Environmental Minor Project Refinement Form

Project Name: West of Devers Upgrade Project Request Prepared By: Sylvia Granados

Date Approval Required: 12/29/2017 Variance Request No.: 3

Southern California Edison
West of Devers Upgrade Project
MPR #3 - Oak Valley Parkway
Telecom Route Work Areas

FIGURE 2
Page 45 of 63

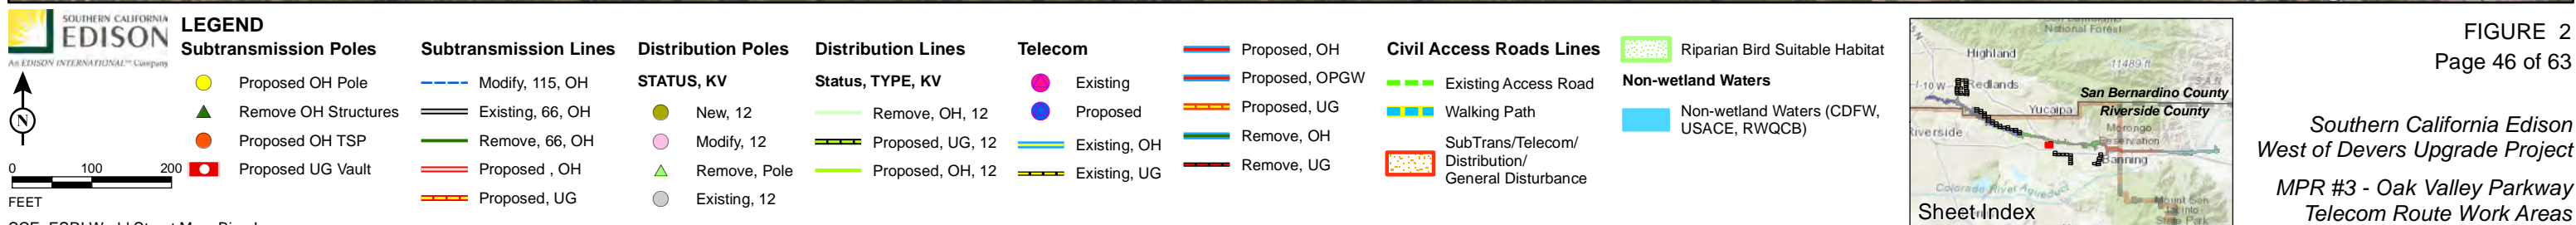
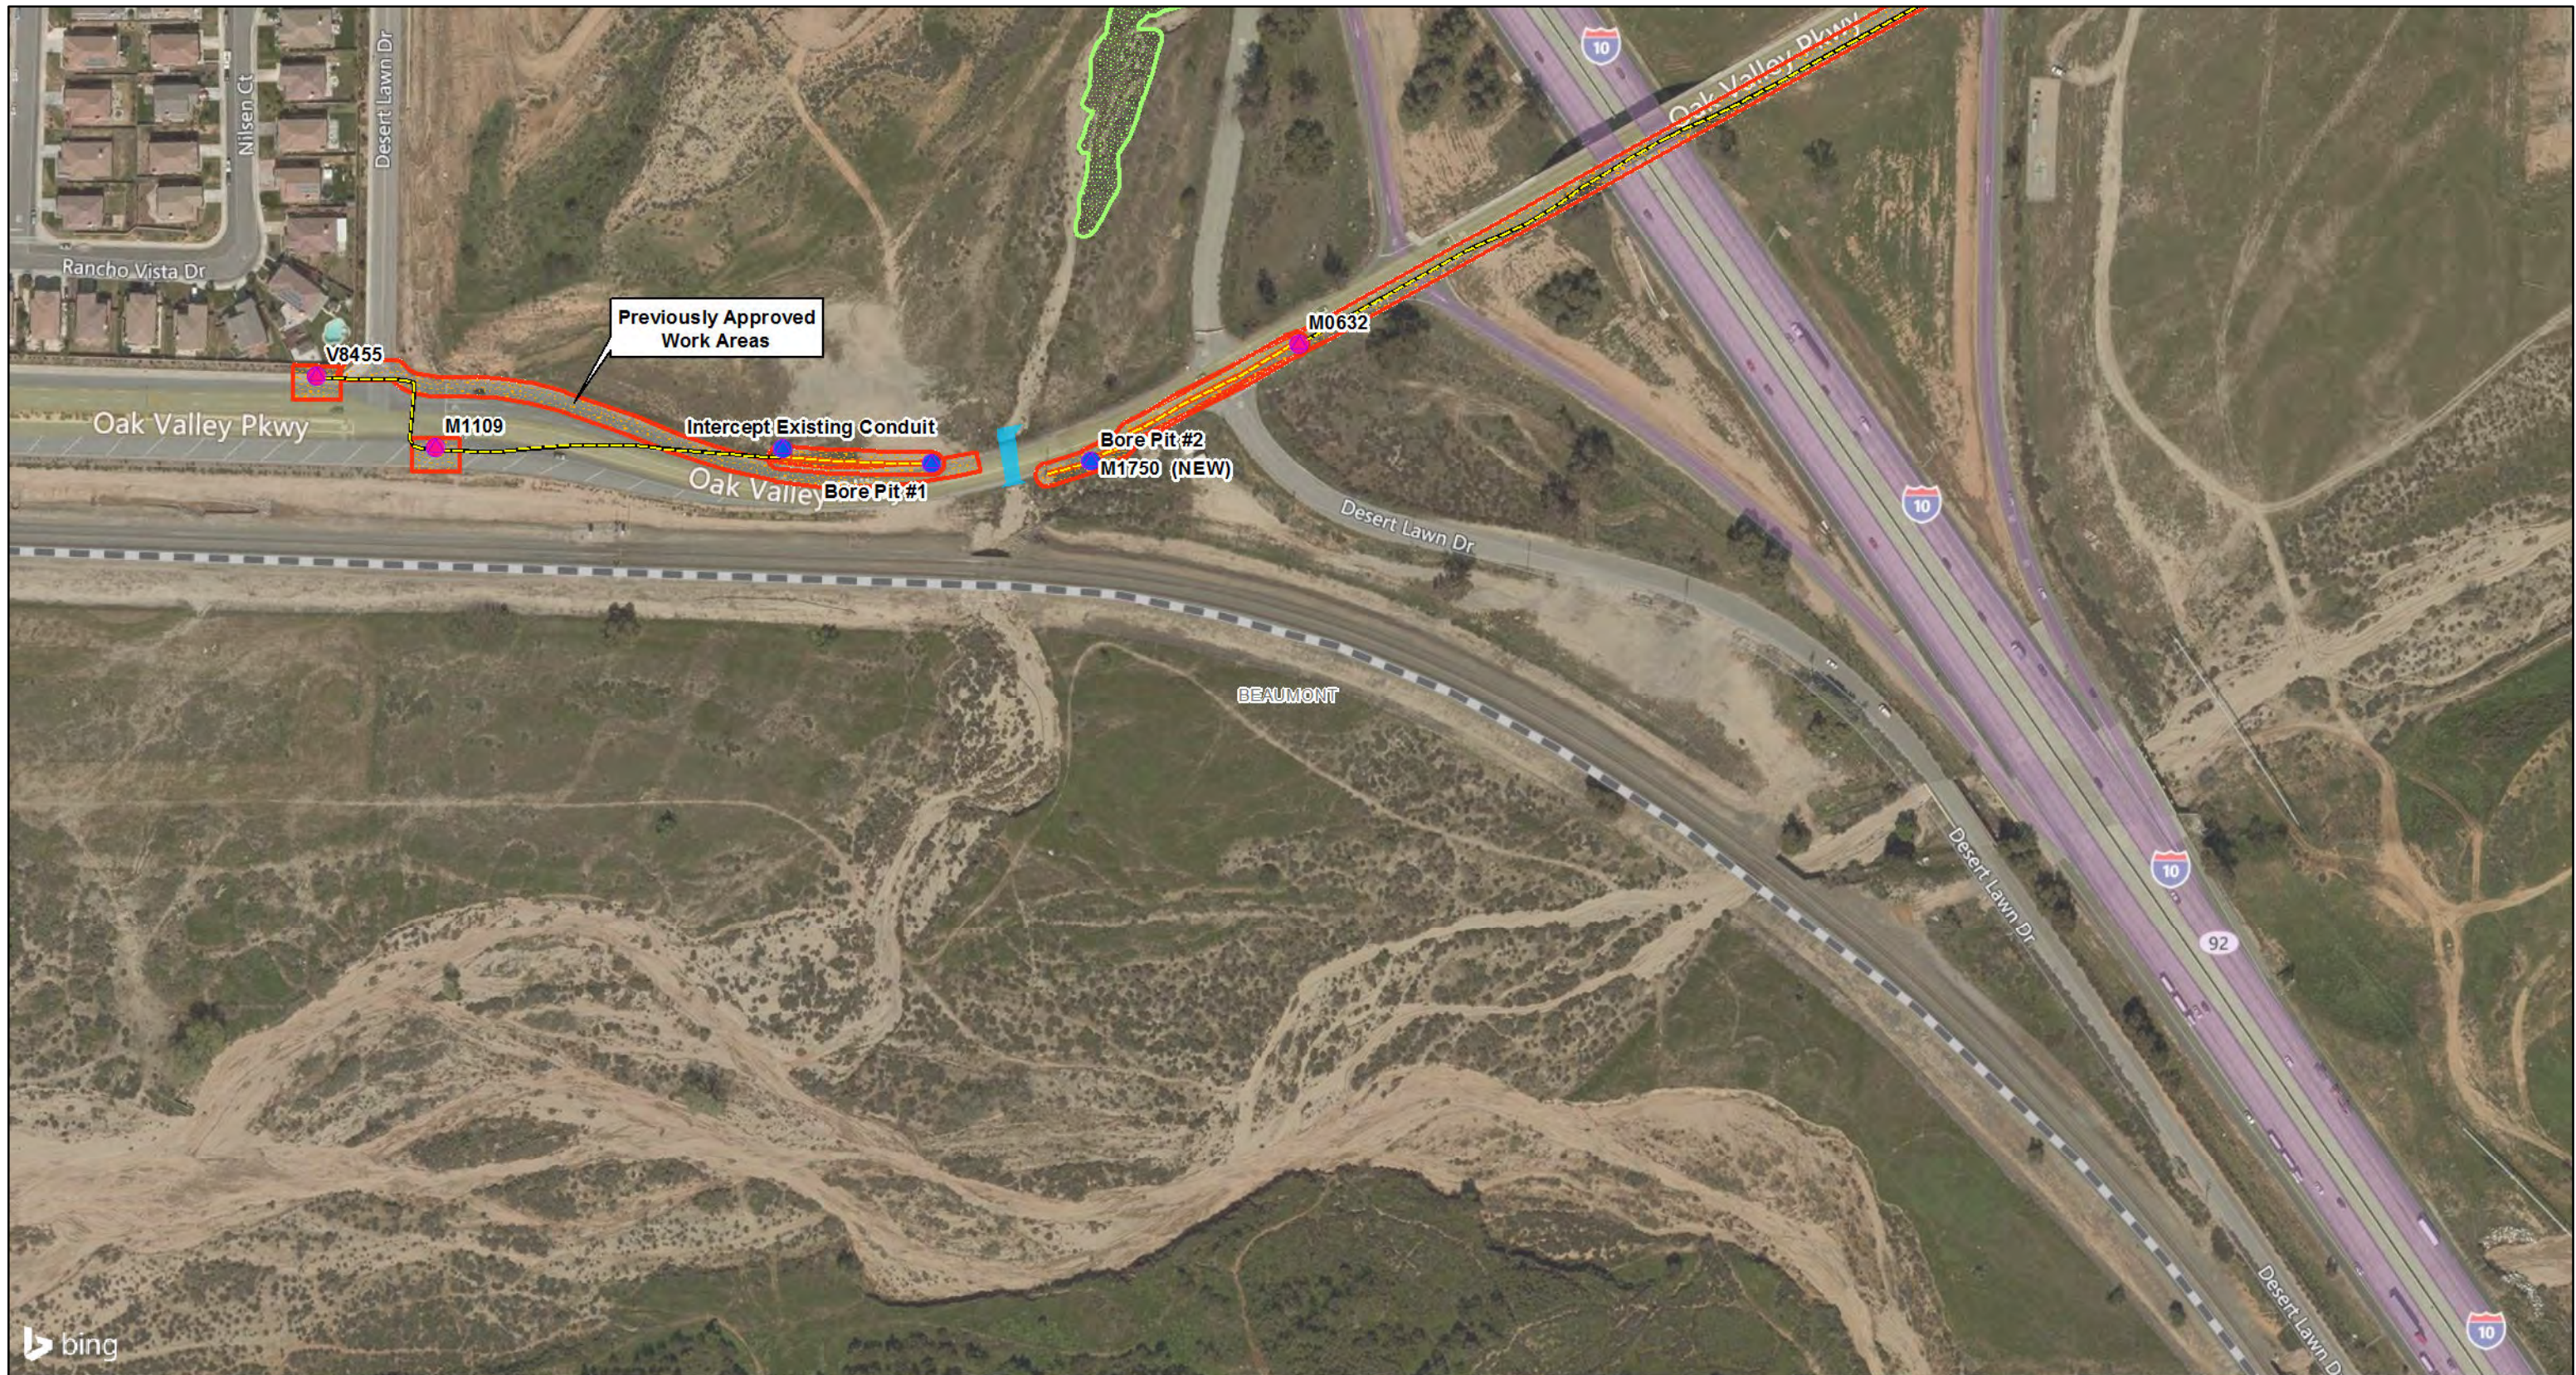
NTPR #3 Map Figure 2, pages 45 and 46, have been revised to reflect a minor shift/adjustment to the previously approved Oak Valley Parkway Telecom alignment. The adjustment has been made to minimize ground disturbance along Oak Valley Parkway and avoid impacts to a jurisdictional water feature, by using existing conduit and horizontal directional drilling (HDD) for the installation of new fiber optic cable. Additional work areas have also been identified to facilitate construction. The adjustments do not create new significant impacts for the project.

The alignment crosses a jurisdictional feature west of Interstate 10 and South Desert Lawn Drive. However, the telecom alignment is designed to avoid the water feature by directionally drilling below a concrete box culvert. The HDD will be installed approximately 10 feet below the closed concrete bottom of the culvert, minimizing the potential for frac-out into the feature. A single 5-inch diameter conduit will be installed via HDD with no casing, to further minimize the risk of potential frac-out. The Contractor will be prepared to implement the CPUC approved frac-out plan and SCE would pursue emergency permitting in the unlikely event of a frac-out. Ground-based activities will not occur within the mapped limits of the jurisdictional feature.
